FINAL SAFETY EVALUATION REPORT

WCS CONSOLIDATED INTERIM STORAGE FACILITY

SPECIFIC MATERIALS LICENSE NO. SNM-2515

Office of Nuclear Material Safety and Safeguards
United States Nuclear Regulatory Commission

Figure 2-1. Proposed CISF 1-mile Radius (Modified SAR Revision 2, Figure 2-3)

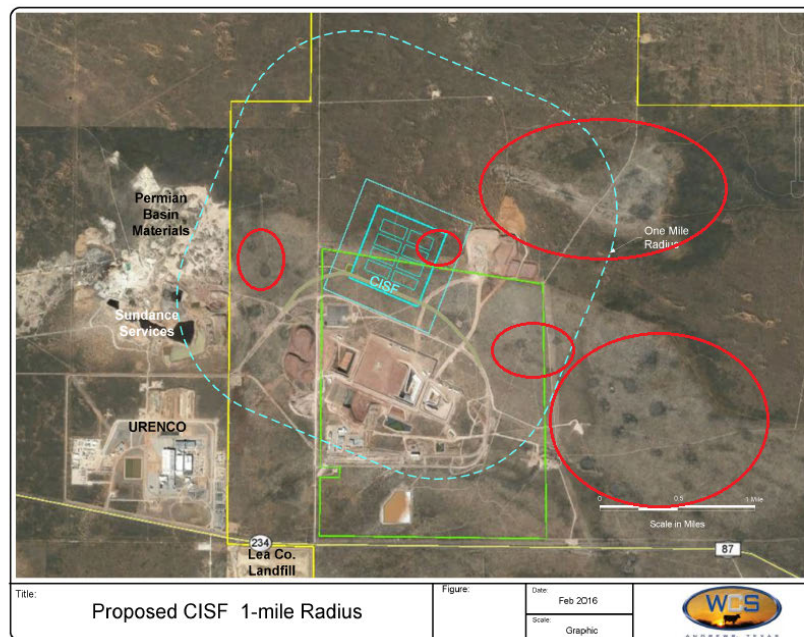
The applicant stated that groundwater may circulate into Permian evaporite deposits because of joint channels opening along Precambrian lines of weakness. SAR Section 2.6.1 states, “near-surface regional structural controls may be locally modified by differential subsidence related to groundwater dissolution of Permian salt deposits.” However, the SAR does not specify where these locally modified areas of differential subsidence are located relative to the proposed site. The staff noted the presence of some features in SAR Figure 2-3, “Proposed WCS CISF 5-Mile Radius,” that are circular in shape (i.e., similar to sinkholes or swales), some of which are shallow depressions 2 to 7 feet (0.6 to 2 meters) in depth.

Accordingly, the staff asked the applicant to clarify the origin of the circular features identified in the red circles on SER Figure 2-1, which is a modified version of SAR Revision 2, Figure 2-3. Specifically, the staff asked the applicant to determine the dimensions of the features and whether these features represent surface deformation at the site due to subsurface dissolution from past or ongoing natural processes or human activities in the site area, as mentioned in SAR Section 2.6.1. The staff also asked the applicant to discuss the potential for similar features to develop at the site in the future.

In its response dated June 28, 2019, the applicant clarified the origin and extent of these features, as well as the relationship of these features and the regional history. The applicant stated that these features started as small erosional depressions in which accumulated water variably dissolved surface or near-surface calcrete and carbonate. The applicant further stated that there is no evidence that these features are the result of human activities, nor that they would form naturally at the site during the licensed period of the proposed facility, and that studies indicate that these features are at least thousands to tens of thousands of years old. The staff reviewed the new information, including a trench report (Holt and Powers, 2017) conducted in one of these features, and determined that the features are not the result of human activities in the subsurface. The staff also determined that because these features take tens of thousands of years to form, new features are unlikely to form at the site during the period of operation.

Figure 2-2
Historical Borings at WCS Site, reproduced from “Submission of ISP Responses for RAIs and Associated Document Markups from First Request for Additional Information, Parts 2, 3, and 4, Docket 72-1050 CAC/EPID 001028/L-2017-NEW-0002,” Enclosure 3, Figure NP-2.6-3-1

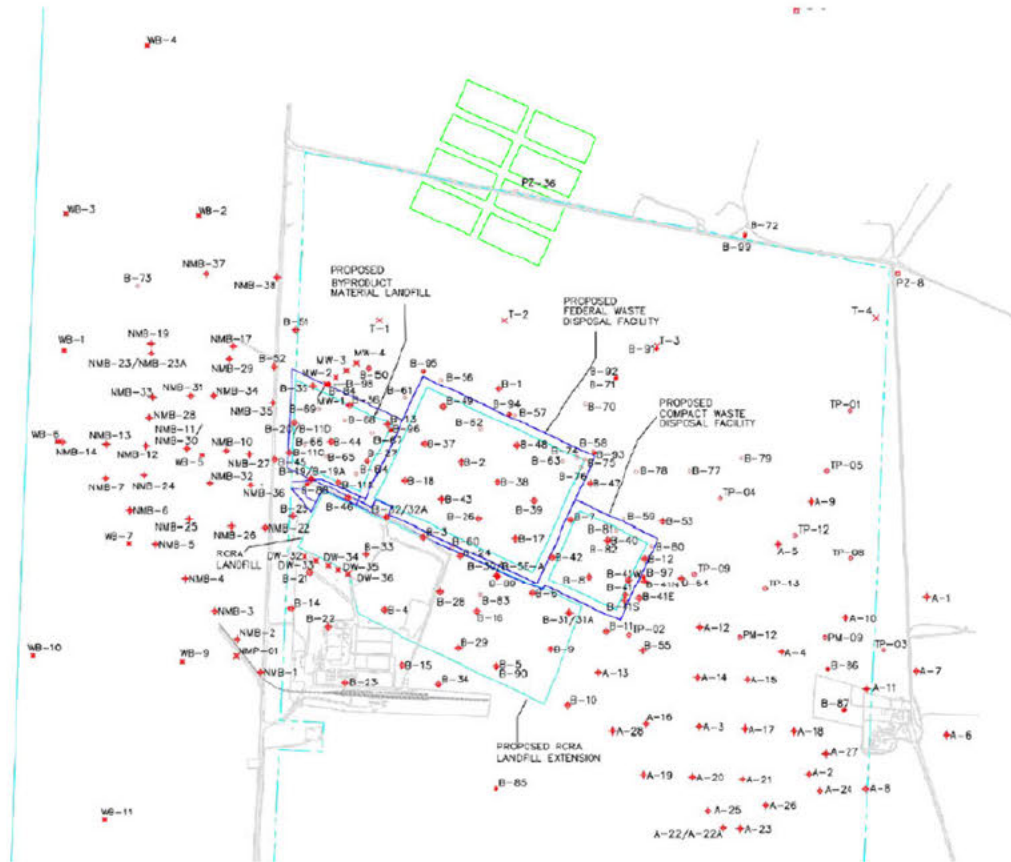
The staff reviewed the applicant's response. The staff noted that the information from the 18 borings and shear wave surveys for the CISF were supplemented with the data obtained from historical geotechnical investigations and geophysical surveys in the site area. These data were used to produce a soil stratigraphic column to 600 feet (180 meters) bgs along with the necessary engineering parameters. The staff compared the geologic stratigraphy to the soil column and found that the shear wave velocities of the soil column correlated well with geologic layer descriptions as shown in Table NP-2.6-3-2 in the applicant's response. The staff also reviewed the applicant's revised report of geotechnical exploration appearing in Attachment E to Chapter 2 of the SAR, and Attachment D to Chapter 2 of the SAR, which contains "Site-Specific Seismic Hazard Evaluation and Development of Seismic Design Ground Motions," Revision 0, dated March 16, 2016. The staff confirmed that the historical data from multiple previous geotechnical investigations and shear wave studies were used in addition to the applicant's report of geotechnical exploration appearing in Attachment E to Chapter 2 of the SAR to extend the soil profile and engineering parameters to a depth of 600 feet bgs. As shown in Figure NP-2.6-3-1 in the applicant's response, the staff observed that the historical borings adequately covered the site area. Further, the staff found that the depth of 600 feet meets general industry guidance of 1.5 times the minimum dimension of footing. Accordingly, the staff concludes that the depth of 600 feet is adequate for the site characterization and engineering evaluation, the method of combining the data from site investigation with historical data available at the site is justifiable, and the information gathered for site characterization and engineering evaluation from the CISF site investigation and historical data available at the site area is sufficient.

In its response dated May 18, 2020, the applicant restated that the historical data available at the site, coupled with the 18 borings and the new shear wave study, have allowed the development of a soil stratigraphic column to 600 feet (180 meters) along with the necessary engineering parameters without additional new soil borings to greater depths. The applicant provided the stratigraphic information by depth and associated material properties, including the static elastic modulus values, for the stratum depth causing settlement, as shown in Table NP-2.6-3-2 in applicant's response.

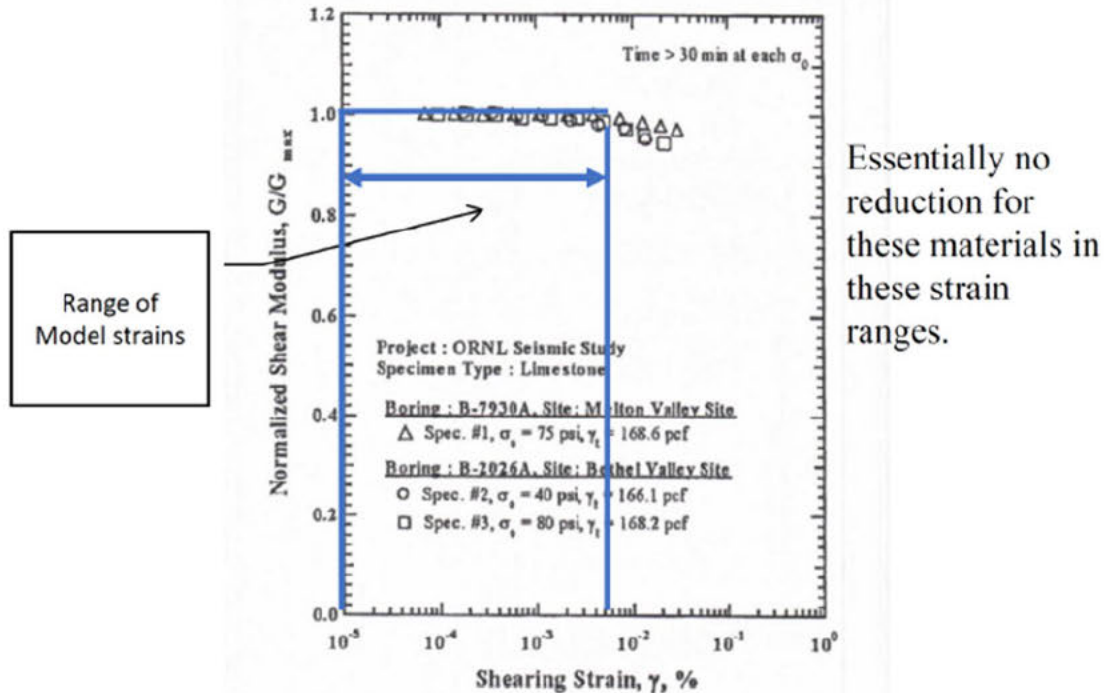
The stability of the subsurface materials and foundations is safety significant. The staff noted that SAR Figure 7-30, "Soil Characterization at Depth," presents the soil characterization by depth and estimated the depth to the red beds (clay) to be 40 to 85 feet (12 to 26 meters). The staff reviewed the settlement evaluation to determine the stability of the subsurface materials but did not find a discussion concerning the evaluation of consolidation and secondary compression settlement, which is a typical geotechnical behavior for clay material. Therefore, the staff asked the applicant to provide a settlement evaluation for consolidation and secondary compression.

The staff review the response. The staff checked Appendix A to the report of geotechnical exploration and confirmed that the boring logs indicate no cohesive soils. The staff also checked the maximum strains by layer with the highest loaded case as shown in Table P-2.6-3-3 in the applicant's response and noticed that the strains for depths of 230 to 600 feet (70 to 180 meters) are very small, on the order of 1×10^{-6} to 1×10^{-7} . Based on the measurements of shear wave velocity, the staff agreed that these layers between 230 and 600 feet deep are rock, not clay. The staff further agreed that the strain-adjusted modulus values for these claystone layers are very high and concluded that the corresponding deformation can be ignored under the very low strains at the depth of 230 feet and below. Therefore, the staff concludes that secondary compression due to cohesive soil is not a concern at the site. In addition, because no consistent permanent water table is observed in the extensive geotechnical exploration of the areas, and most of the subsurface beneath the CISF site consists of unsaturated moisture-deficient materials, the staff further concludes that consolidation is negligible at the site.
